14 Lower Granton Road

Walk and Cycle
Improvements

Consultation Summary Report

Figure 5 Lower Granton Road Proposals (5 of 8)

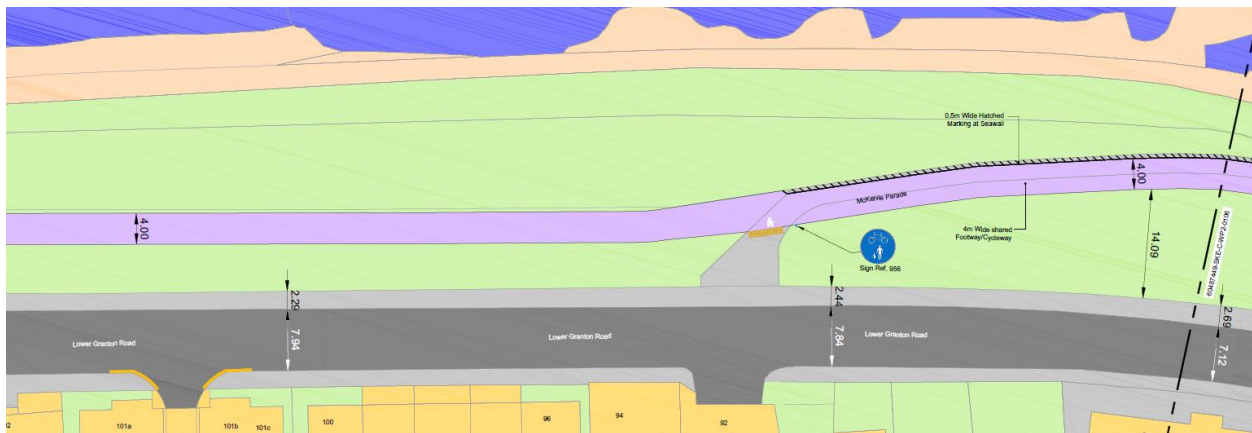
2c - Sight lines need to be considered for the approach to the “kink” in the path for the slipway access (Sheet 4). The path should be made as straight as possible, taking into account the existing bridge.

| 17 | Strongly support | Yes. Although I really like the designs from a safety point of view, on page 4 the drawing show a raised path. From my experience, cars park there illegally on the pavement, so I would recommend that bollards are placed there. | The raised table crossing, at the entrance to Wardie Bay Beach, shall be changed to a continuous footway which gives greater priority, safety and ease of use for people on foot and bike. We shall include parking restriction measures to prevent parking here. |

Map included in e-mail

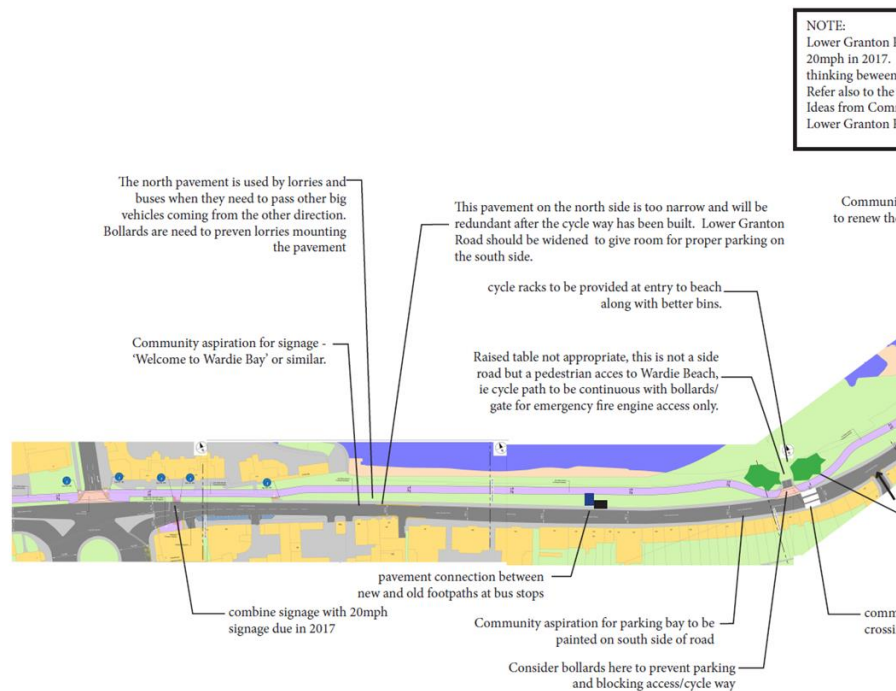
| 09/12/16 | Local Resident | <ul style="list-style-type: none"> • Generally I support a cycle/walk way along LGR. • It would be good to see some joined up thinking between this proposal and the implementation of the 20mph limit which is due in 2017. • Please take into consideration the community aspirations of the Sustrans Report: Captured Ideas from Community Engagement in Lower Granton Road which you have issued to us. • The area at the entry to Wardie Beach needs better landscape design treatment. Wardie Beach is very popular in the summer with hundreds of people using it on warm evenings and weekends. It is a focal point for the local community. The raised table suggestion is not appropriate and the area should be pedestrianized with emergency access bollards to prevent parking. Good quality hard landscaping combined with better bins and cycle racks and signage could enhance the entrance to the beach. • The north pavement to Lower Granton Road is problematic. It is often used by lorries and buses to pass other big vehicles coming the other way. As most pedestrians will now probably use the new path should this pavement could be removed, or bollards could be installed to prevent pedestrians mounting the pavement. The road could be re-aligned to allow a proper full width of parking to the south and two vehicles to pass safely? • The bus stops should be shown on your plan and there should be pavement to connect the old and new footpaths at bus stops. • Consideration needs to be given to the landscape strip to the north of the new cycle way between it and the sea wall. • The community wants to make Wardie Square one-way, can this be encompassed within this proposal and the 20mph initiative? • Can a meeting be set up between out and the residents of Lower Granton Road to discuss this? | E-mail consultation | <p>The Sustrans report was reviewed and considered in the design, however the wider issues on Lower Granton Road that it highlights are beyond the scale and budget of this scheme.</p> <p>We shall change the raised table at the entrance to Wardie Beach into a continuous footway. This will increase pedestrian priority. Cycle racks will also be included but further landscaping is beyond the current scope of budget of the scheme.</p> <p>Based on the available budget we do not have the scope to alter the road layout and landscaping as you have requested.</p> <p>A public meeting was organised and publicised to discuss the designs.</p> |
